ADDENDUM THREE

City Project Number: T-15-010
TDOT Project Number: 123398.00

Manufacturers Hamm Gateway

This addendum includes a correction to the typical section call out number 10 and
quantities.

SHEET NUMBER: 2B5

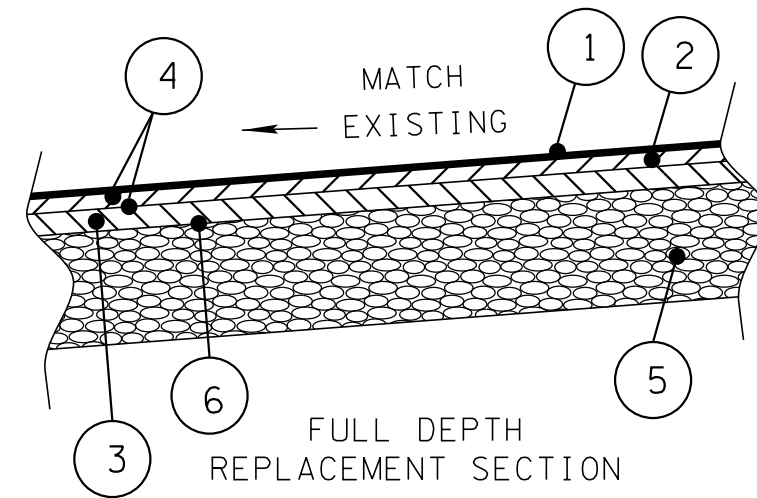
REV. 08.12.24
ADDED ITEM NUMBER TO
PAVEMENT CODE 11.
